On February 9, 2016 the City of Tualatin approved with conditions AR 15-0027 for Ruth T LLC Building #6 located at 12171 & 12225 SW Herman Rd (Tax Lot: 2S122C00602 & 606).

## ARCHITECTURAL REVIEW FINDINGS AND DECISION

Case #: AR-15-0027  
Project: Ruth T LLC Building #6  
Location: [12171 & 12225 SW Herman Rd.](#) (Tax Lots 2S1 22C 000602 & 000606)  
Applicant: Ruth T LLC; David Silvey, PO Box 205, Tualatin, OR 97062  
Project Contact: Silco Commercial Construction; Rory Antis, rantis@silco.info; 8316 N. Lombard #451, Portland, OR 97203. (503) 286-8691

**SITE PLAN**

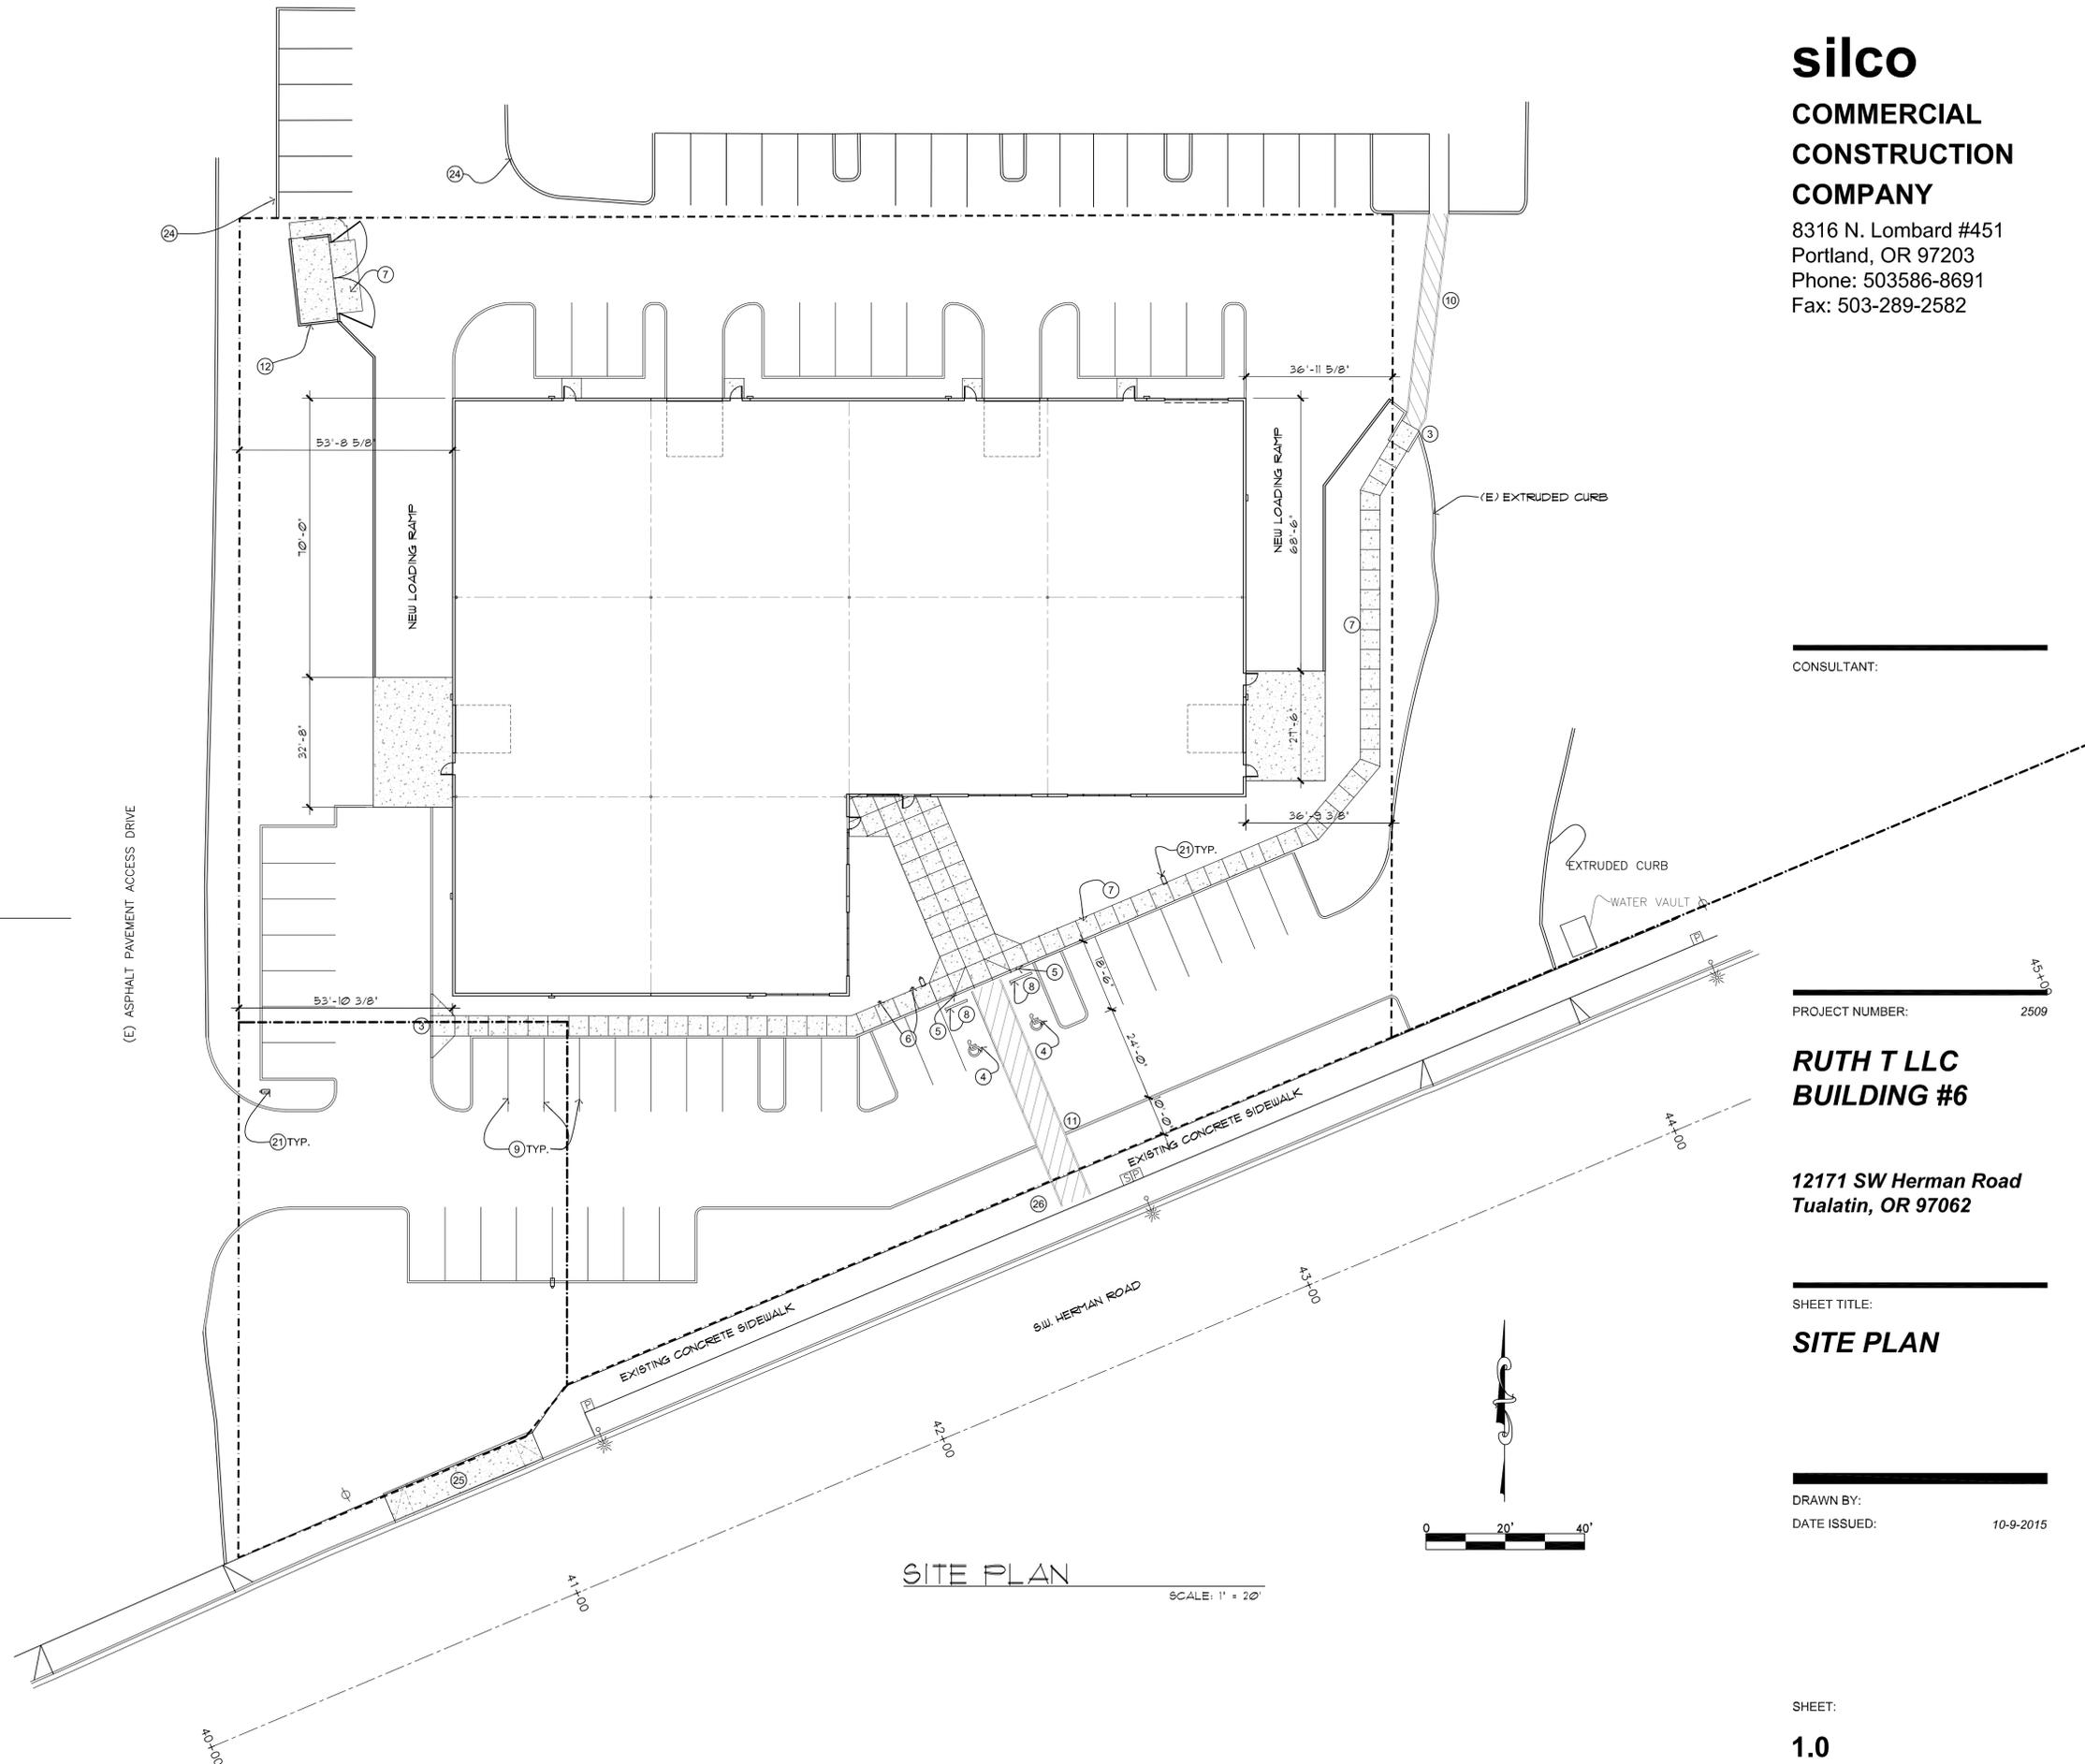
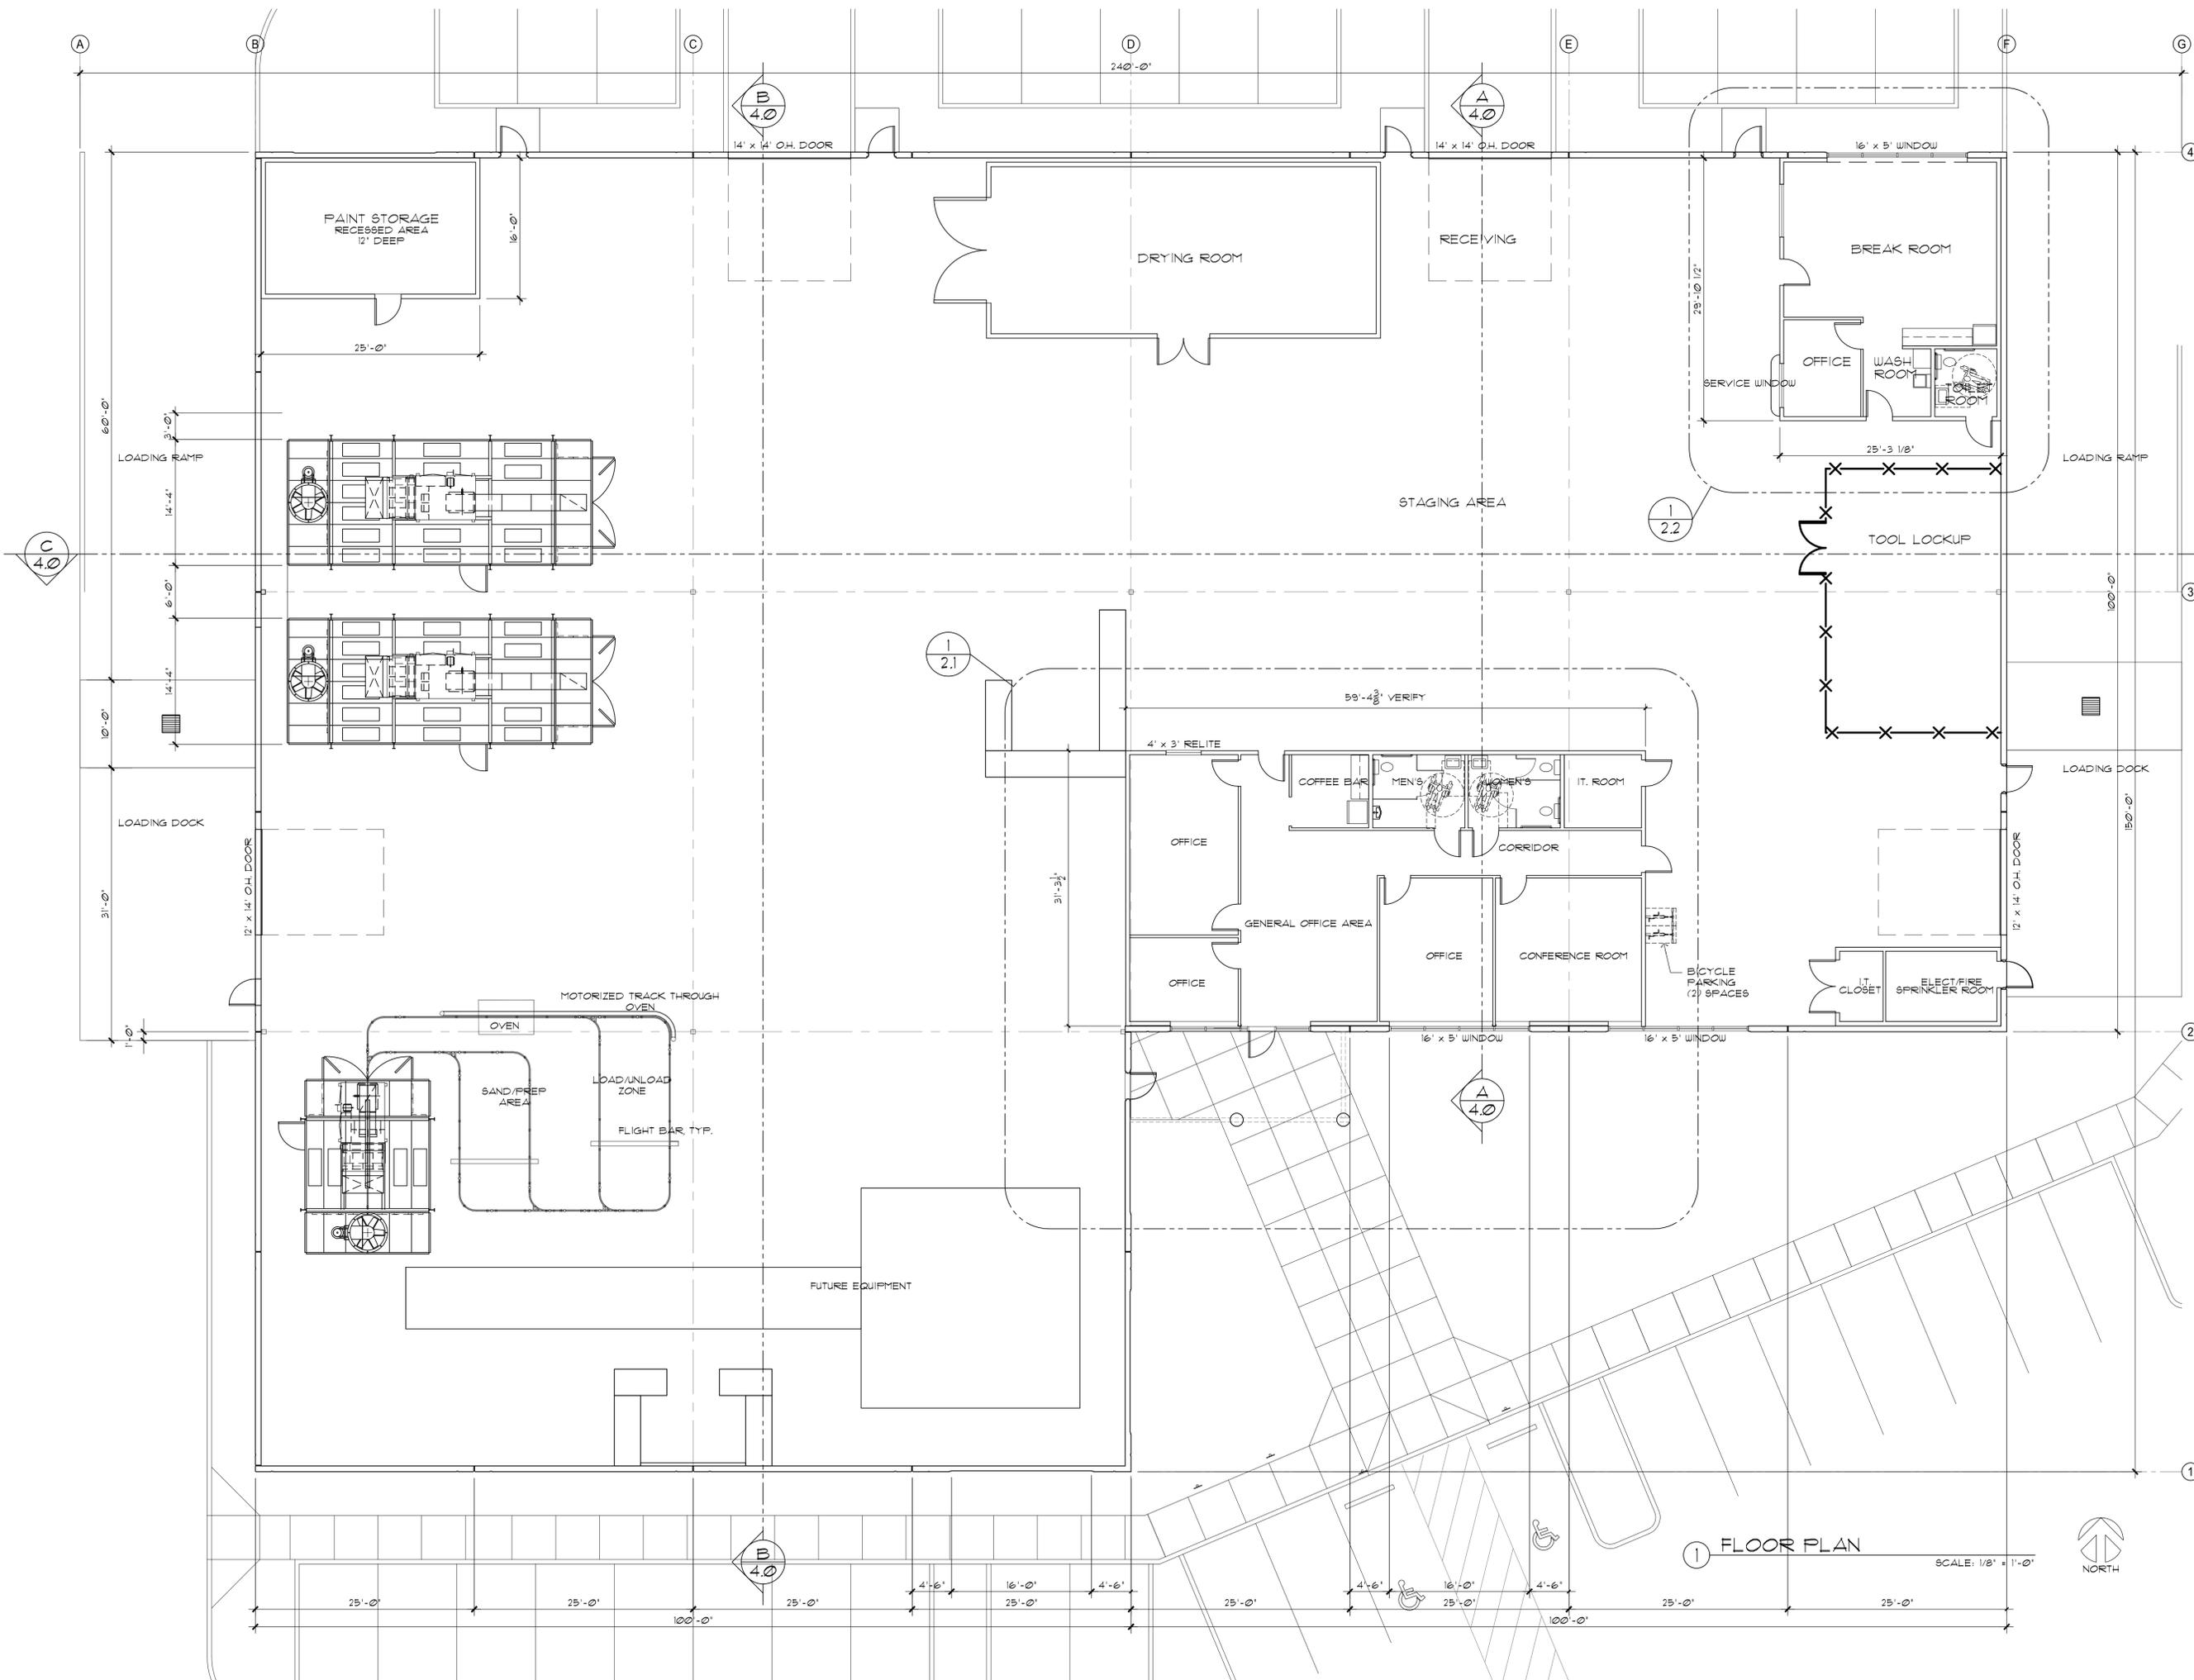
The site plans illustrate parking and circulation area setbacks of at least 5 ft abutting properties, except across the rear property line where there is a shared parking aisle. Site plan Sheet 1.0 shows a setback of 10 ft adjacent to Herman Road. However, C2 shows a setback of 6 ft, and the applicant’s narrative in a table on page 10 indicates 9’ – 4” at the same location. The minimum setback is 10 ft and the standard shall be met. Sheet C2 must be corrected. Otherwise, the proposal meets the requirements. The lot does not adjoin a residential or MP Planning District.

For access to SW Herman Road, the applicant proposes to use an existing entry drive on the adjacent property. The configuration of the drive is such that the western 5 foot wide landscape area defining the entrance, required by the code, will lie mostly on the subject site. As shown on Site Plan Sheet 1.0, the area is only 10 feet at this entrance. An area at least 5 feet wide must extend 30 feet along the entry drive. The site plan must be modified.

SHEET:  
**3.0**

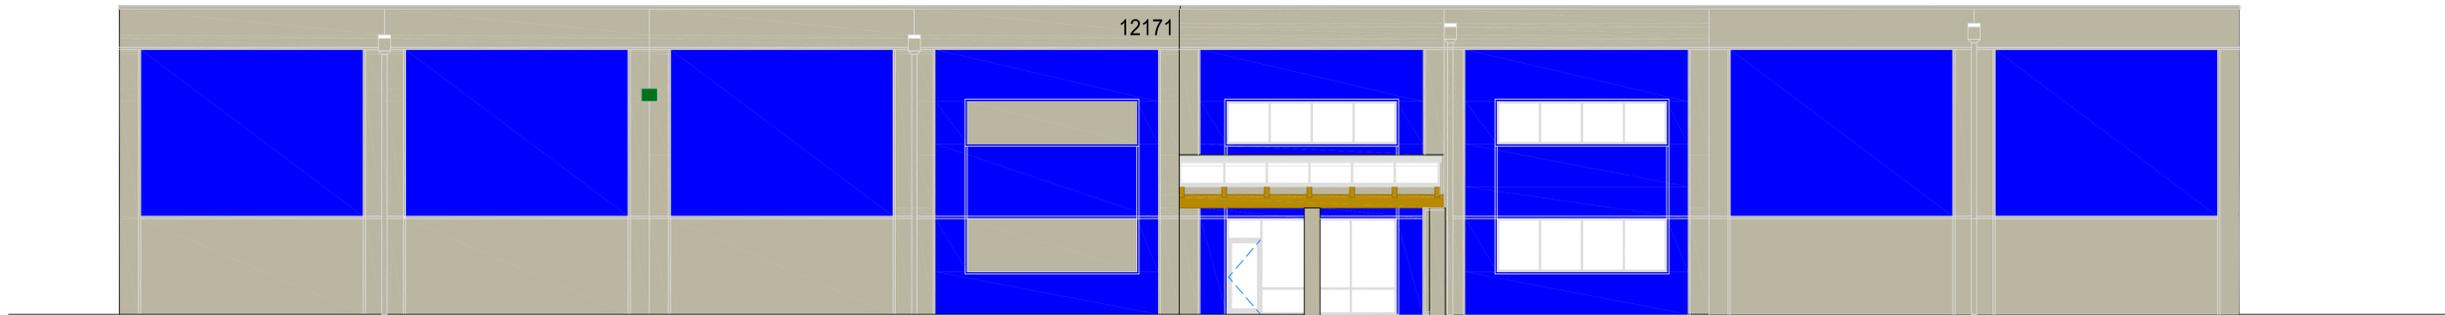
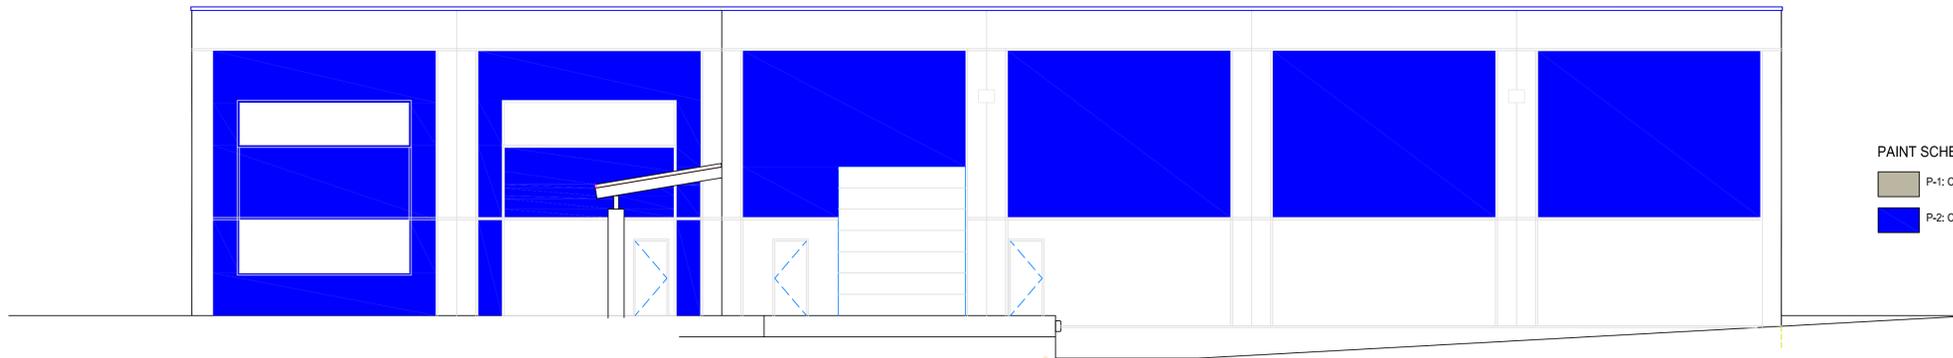
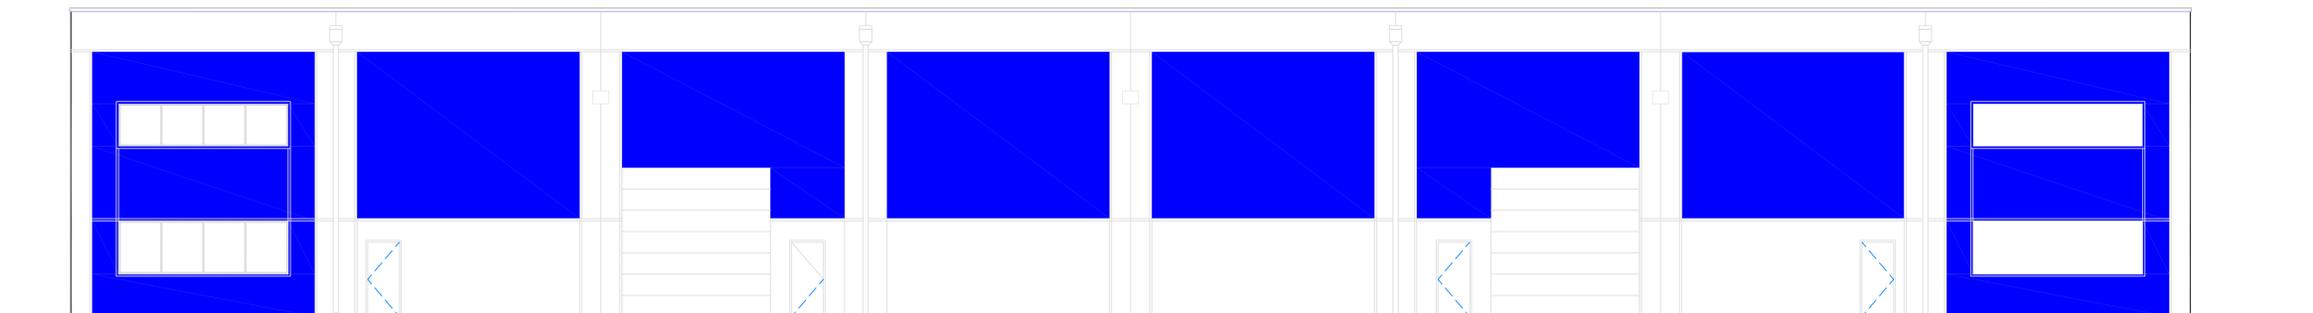
The exterior elevations (Sheet 3.0) show the proposed building height is 29 ft. The proposal meets the requirement.

Staff notes that several windows on Exterior Elevations Sheet 3.0 are labeled as "Future" windows. Without these, there are windows on only two elevations, one elevation being one wall of the inside corner of this L-shaped building. With pedestrian, parking and loading areas on all sides of the building, casual surveillance is limited.
